Re: Blvd. 2500
2500 Carlisle Blvd. NE
Traffic Circulation Layout
Architect's Stamp 06-30-23 (H17-D002A)

Based upon the information provided in your submittal received 07-03-23, the above referenced plan cannot be approved for Building Permit until the following comments are addressed:

DRAINAGE AND TRANSPORTATION INFORMATION SHEET

TRAFFIC CONTROL LAYOUT

18007
TCL102

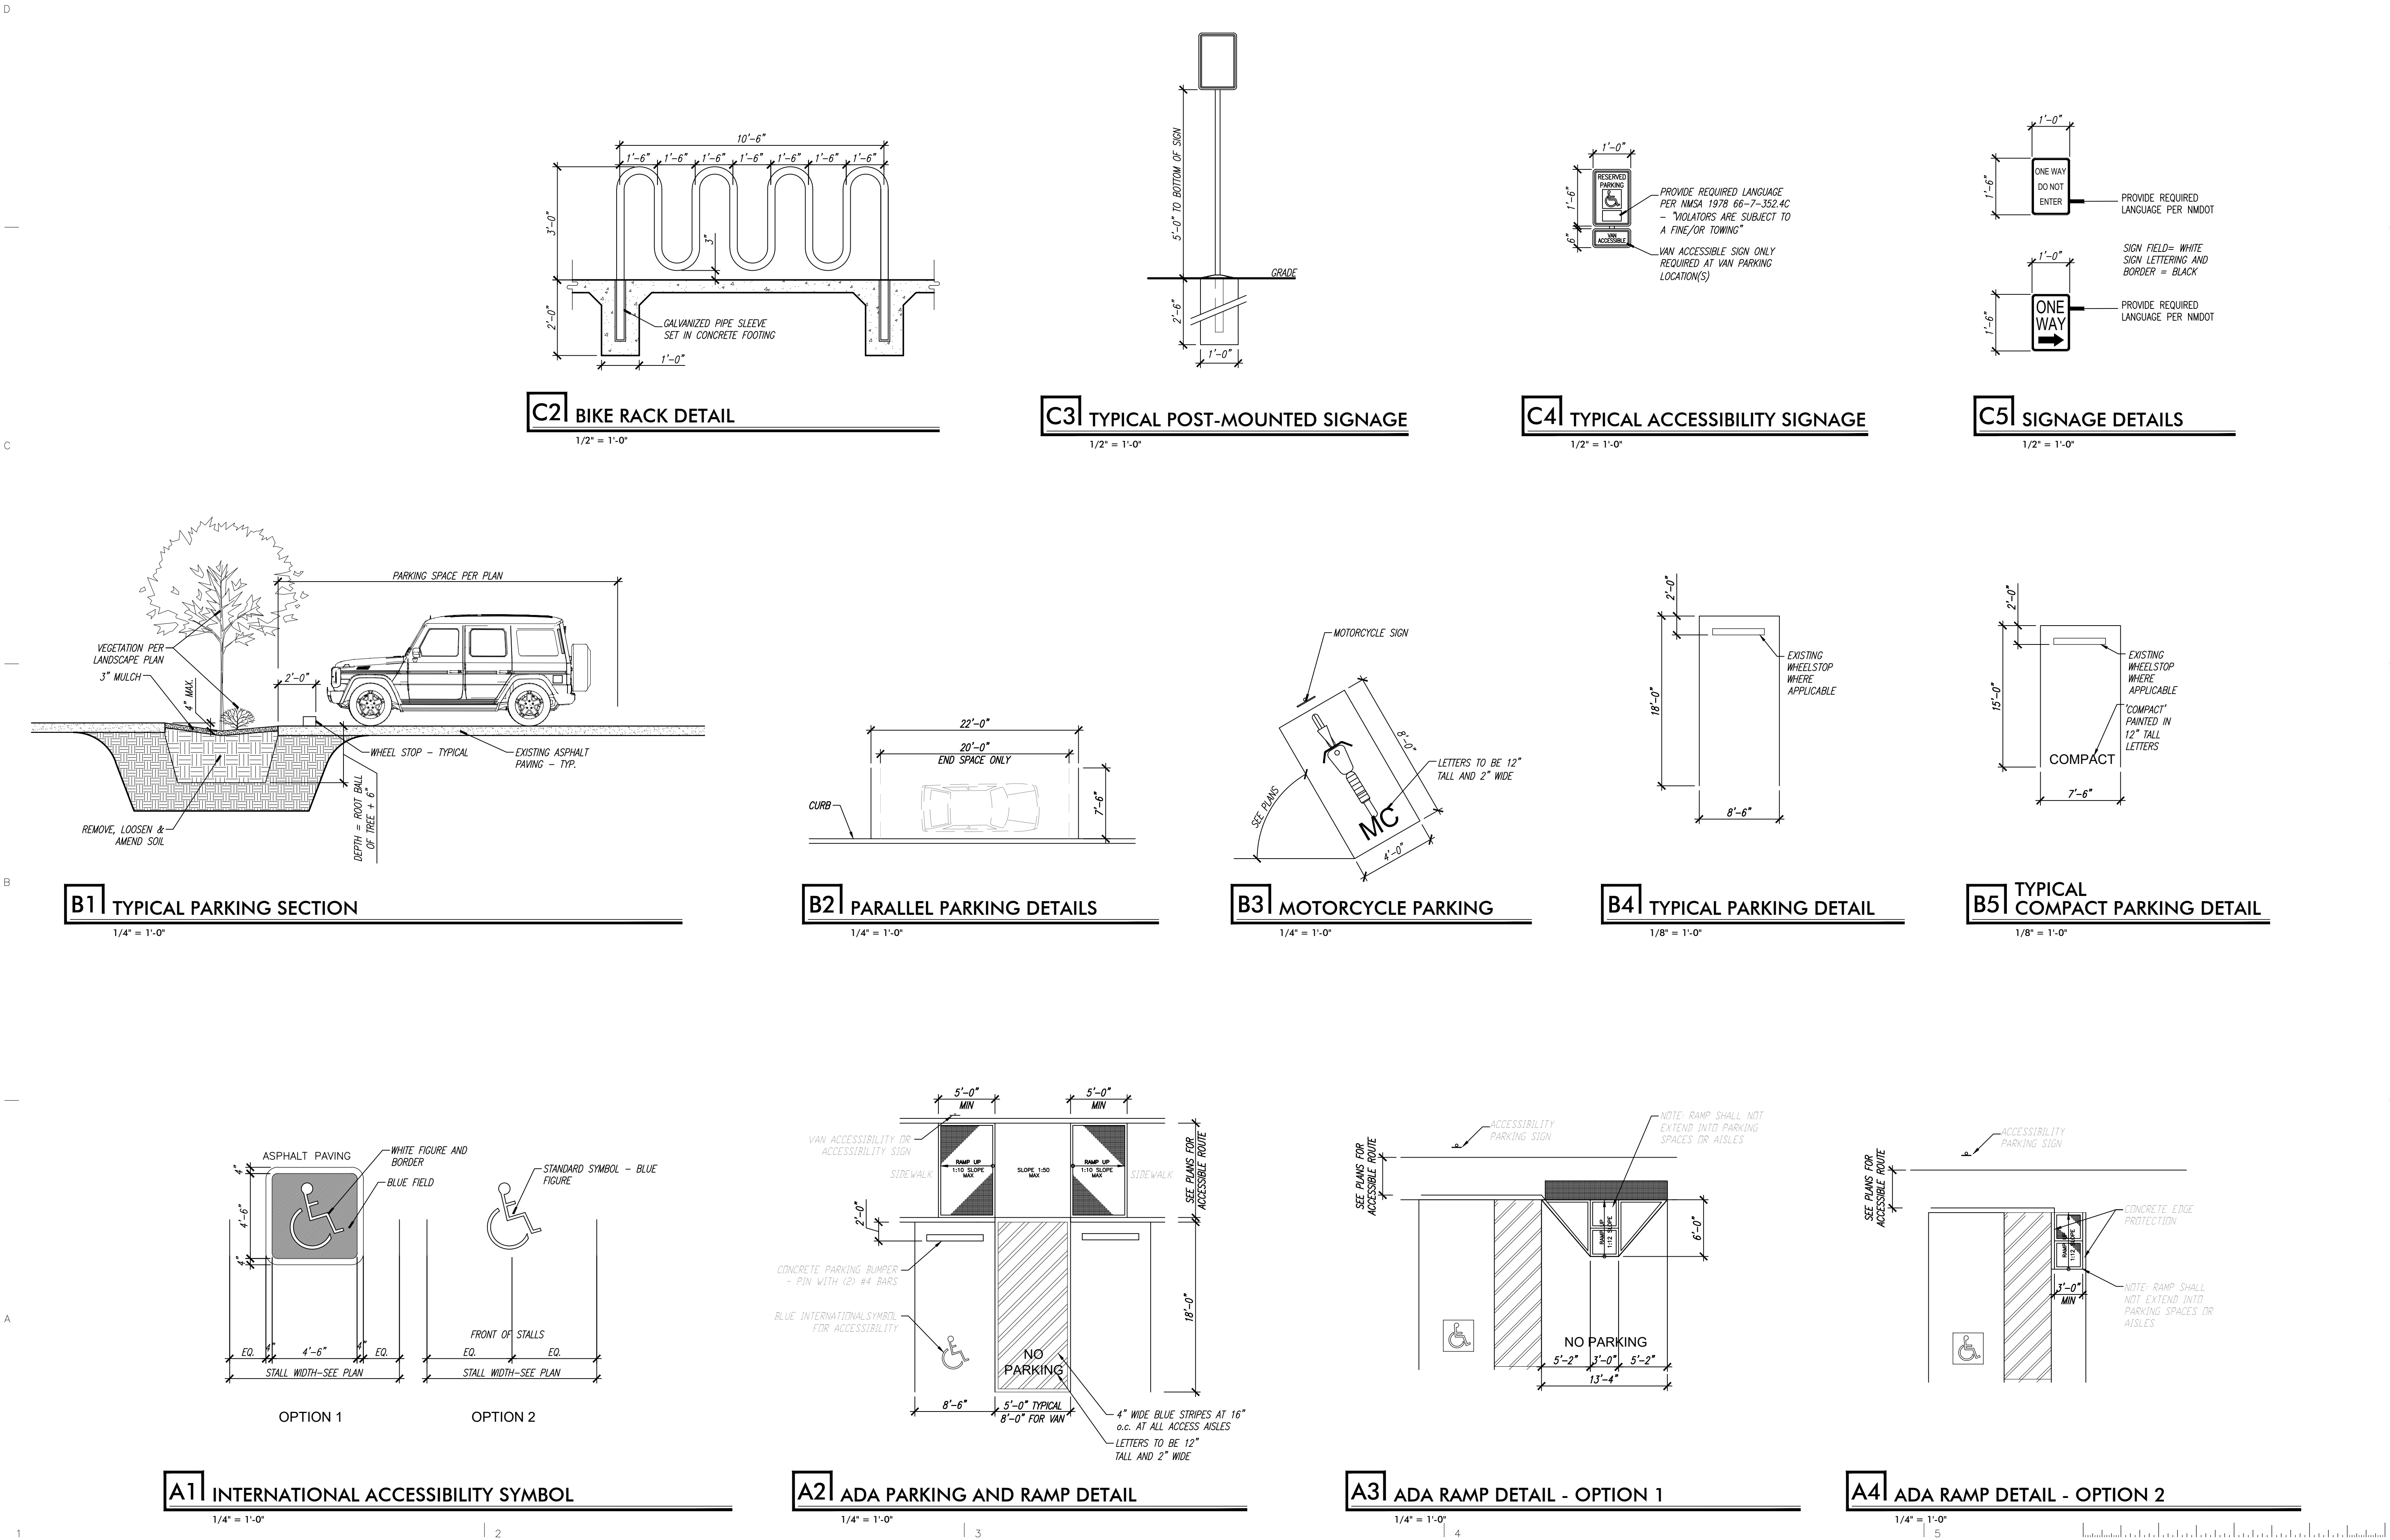
1. Identify all existing access easements and rights of way width dimensions.
2. All site accesses driveways must be updated to current standard and have truncated domes installed. Please provide driveways' design details and reference COA std dwg.

3. Please provide the angle for the existing and proposed angled parking. See attached angled parking requirements.
4. Minimum Drive Aisle Width for two ways traffic is 22 ft. please revise the site plan.

5. In addition to the "ONE WAY" signs, please provide "ONE WAY" pavement marking.
6. Per the IDO, a 6 ft. wide ADA accessible pedestrian pathway is required from the public sidewalk to the building entrances. Please clearly show this pathway and provide details.

7. Per DPM, a 6 ft. wide ADA accessible pedestrian pathway is required from **EACH** ADA parking stall access aisles to the building entrances. Please clearly show this pathway and provide details.

8. ADA accessible pedestrian pathway should not be placed behind parking space or adjacent to a vehicular way. Vehicle and pedestrian/wheel chair conflicts should be avoided as much as possible.

9. Motorcycle parking spaces shall be designated by its own conspicuously posted upright sign, either free-standing or wall mounted per the zoning code.

10. The pavement marking "MC" should be shown in the opposite direction for motorcycles entering the parking space.
11. Please provide Hoop Bike Rack.
12. All bicycle racks shall be designed according to the following guidelines:

16. Refuse vehicle maneuvering shall be contained on-site. The refuse vehicle shall not back into the public right of way.; provide a copy of refuse approval.

17. Provide a copy of Fire Marshall approval.
 18. It is not apparent what type of pavement surface is being proposed. A hard driving surface will be required as part of this proposed project for parking area and drive aisles.

19. Please provide a sight distance exhibit
 20. Show the Intersection clear sight triangle for the southwest site access and show the regular clear sight triangle for the other site accesses and add the following note to the plan: "Landscaping and signage will not interfere with clear sight requirements. Therefore, signs, walls, trees, and shrubbery between 3 and 8 feet tall (as measured from the gutter pan) will not be acceptable in the clear sight triangle.

21. Please specify the City Standard Drawing Number when applicable.
 22. Add a note stating "All broken or cracked sidewalk must be replaced with sidewalk and curb & gutter." A build note must be provided referring to the appropriate City Standard drawing.
